SUBJECT: Forwards response to NRC RAI to support technical review of
util 920225 proposed license amends re OL expiration date.

Re: Turkey Point Units 3 and 4
Docket Nos. 50-250 and 50-251
Request for Additional Information (RAI) -
Proposed License Amendments
Operating License Expiration Date

RESPONSE TO NRC QUESTIONS

PROPOSED LICENSE AMENDMENTS:
OPERATING LICENSE EXPIRATION DATE

GENERAL ARRANGEMENT
INTAKE STRUCTURE
(PLAN VIEW @ EL 16'-0")

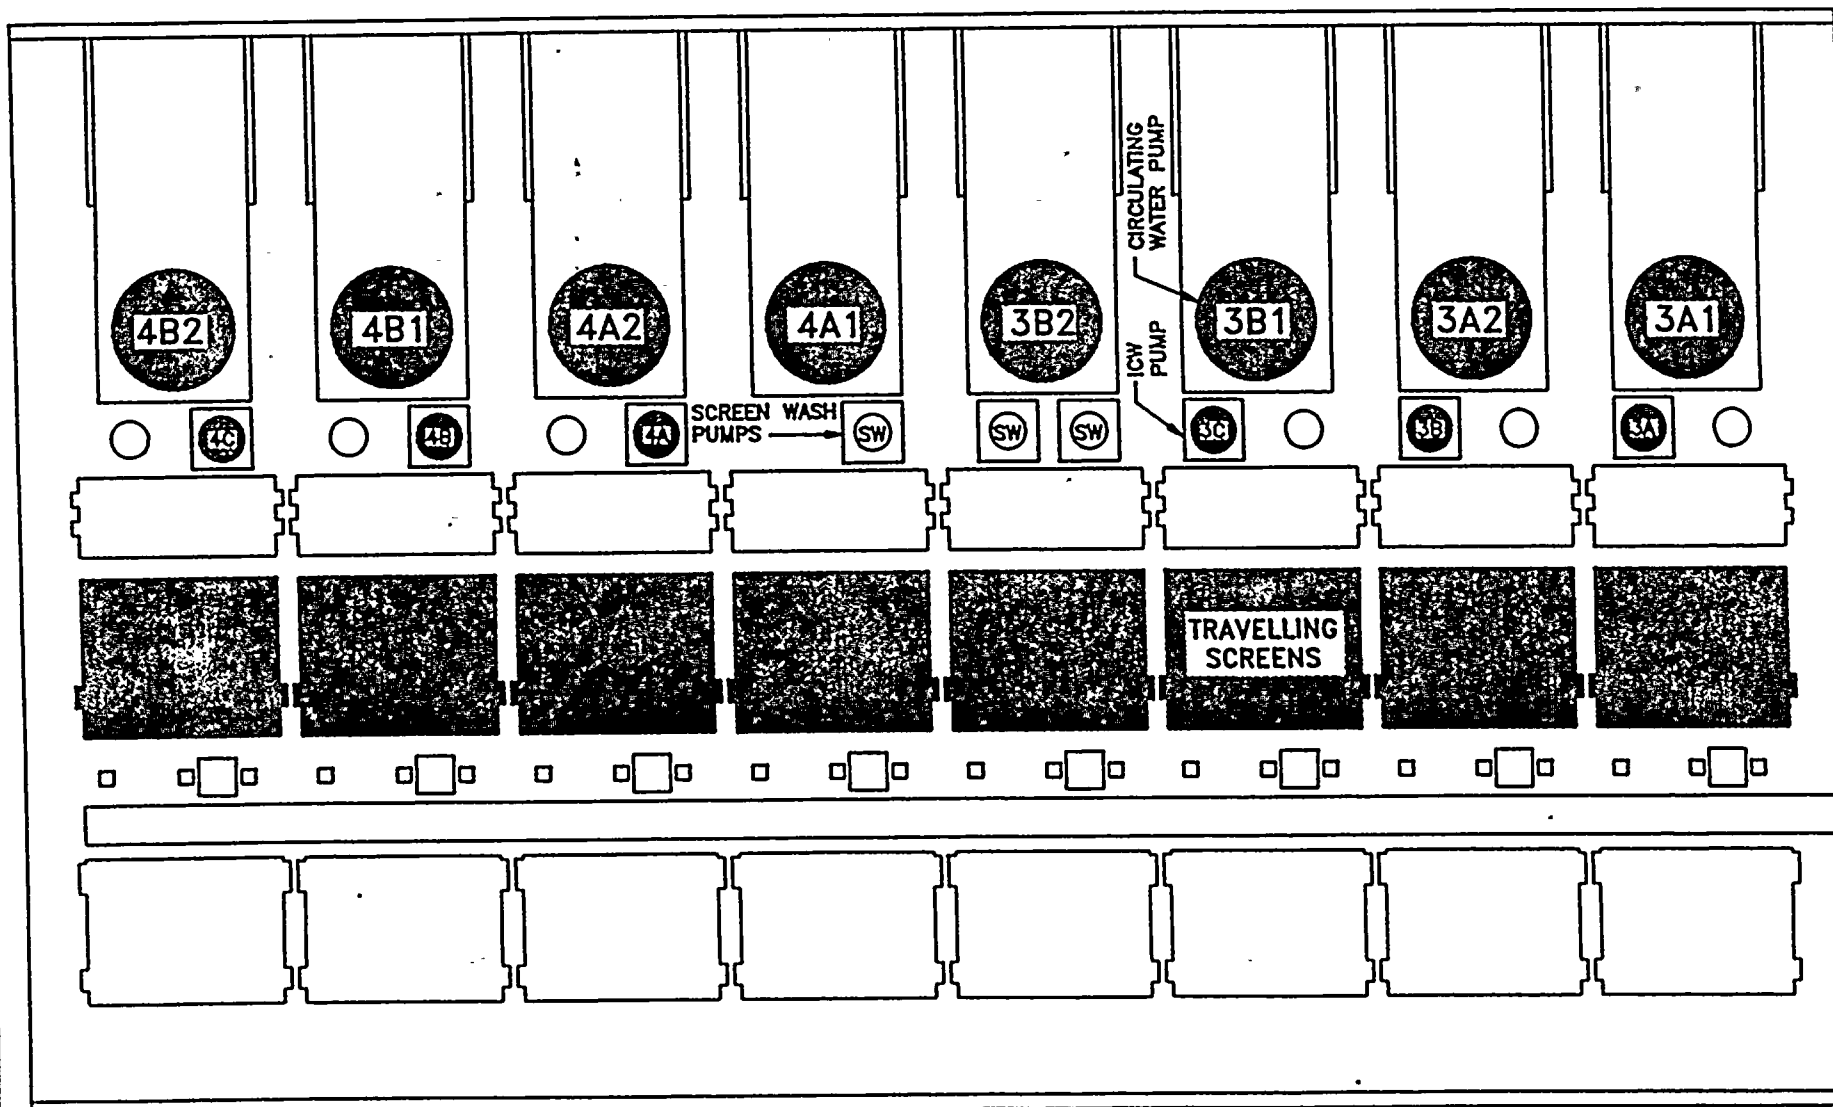
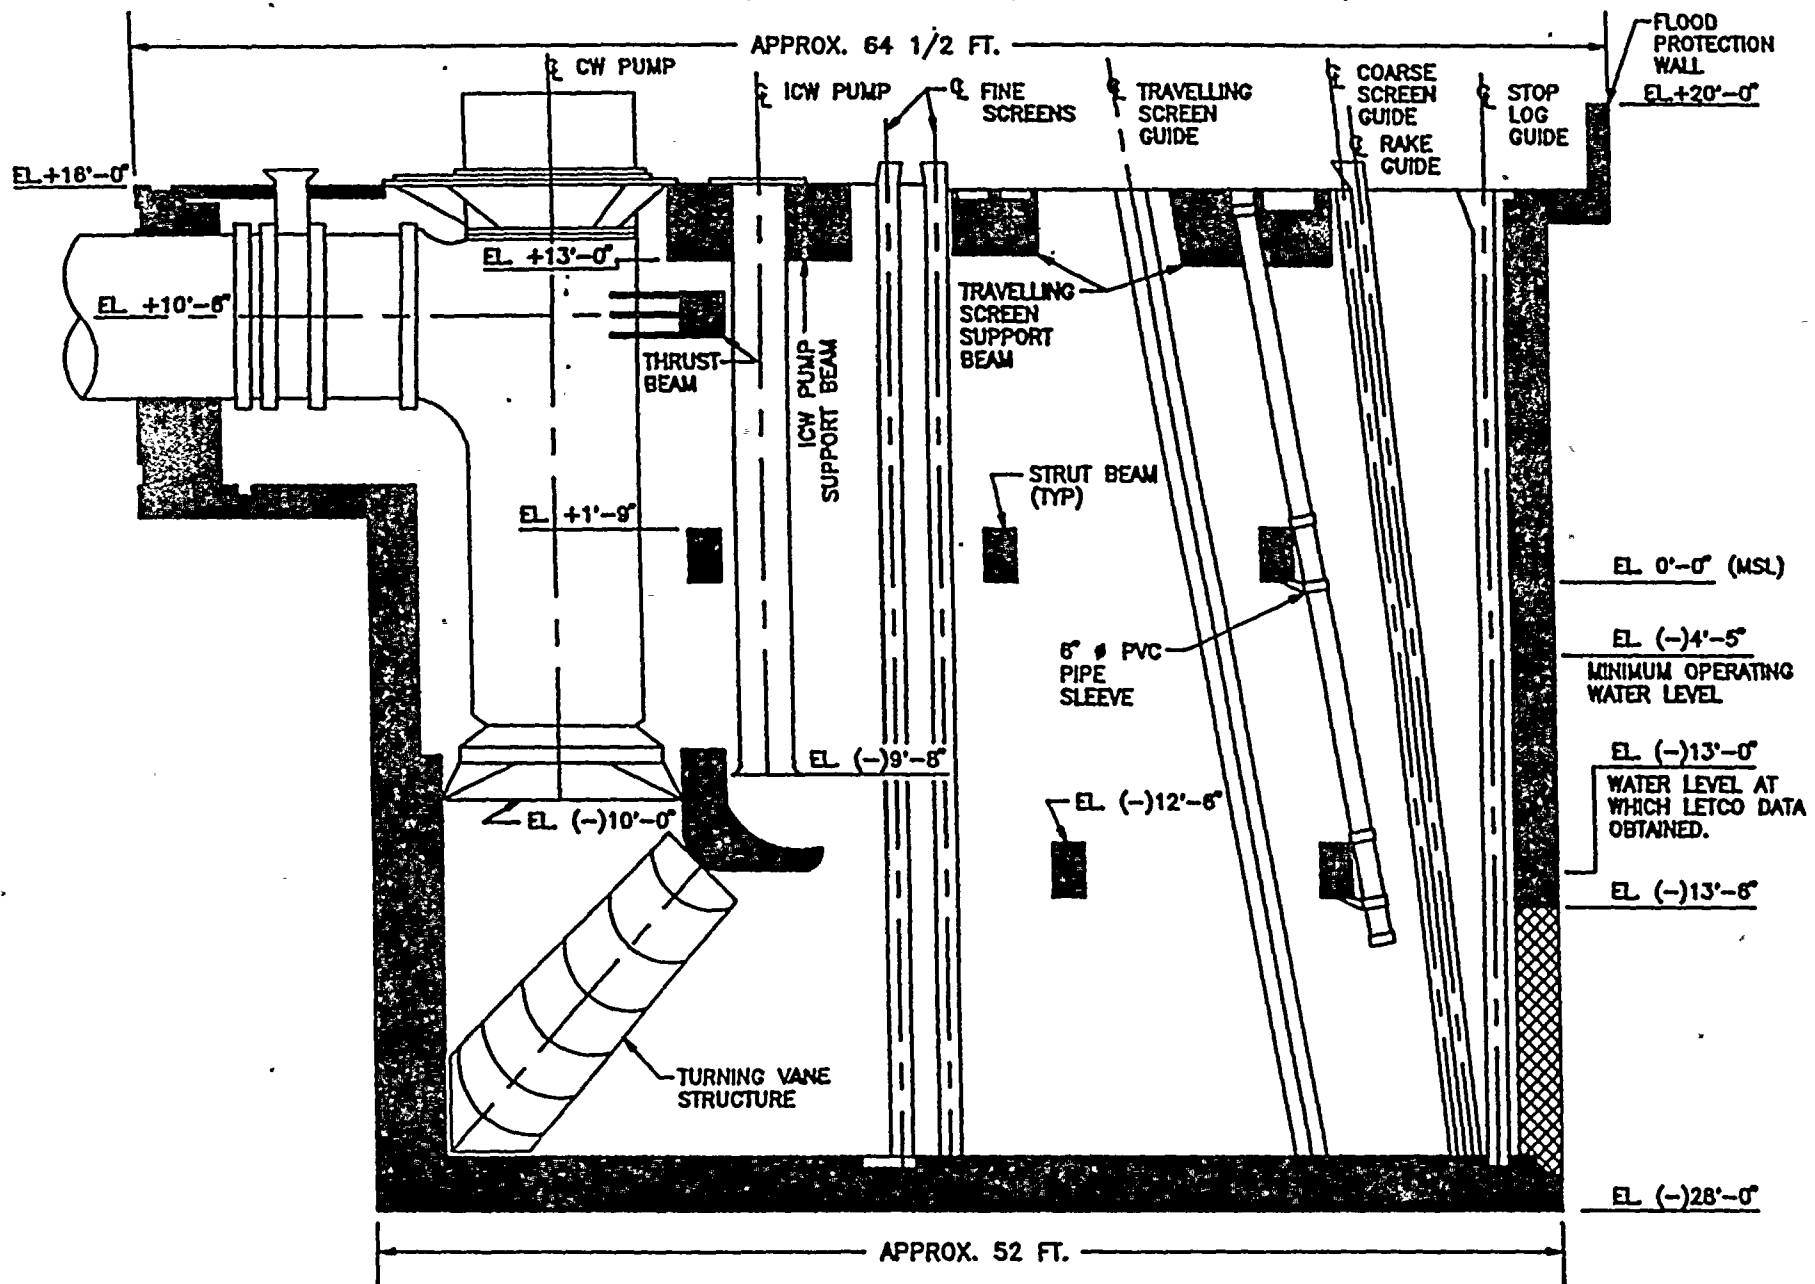
For the duration of the proposed license term, confirm the intake structure's functional capability to support the cooling water pumps and to deliver adequate cooling water to safe shutdown equipment during and following a postulated seismic event (refer to Law Engineering Testing Company on corrosion evaluation of Turkey Point intake structure dated December 4, 1986).

The main structural components of the intake structure, which are composed of reinforced concrete, are depicted in Attachment 1. They consist of the foundation, bay walls, horizontal struts including Circulating Water (CW) pump thrust beams, and deck support beams for the Intake Cooling Water (ICW) pumps, CW pumps, and travelling screen equipment.

In 1985/1986, inspections of the structure by FPL identified erosion/corrosion of the CW pump thrust beams, horizontal struts at the 1'-9" elevation, and the deck support beams for the ICW pumps. The most significant degradation was present on the CW pump thrust beams. Due to the degree of damage, the beams were replaced. Repairs were also made to the strut beams at elevation 1' - 9" and to the ICW pump support beams. These members reside in the wet/dry zone which is heavily oxygenated, are exposed directly to intake canal water which has a high chloride ion concentration, and have 3 inches of concrete cover over the reinforcement (as required by the American Concrete Institute (ACI) code of record at the time of construction). Other
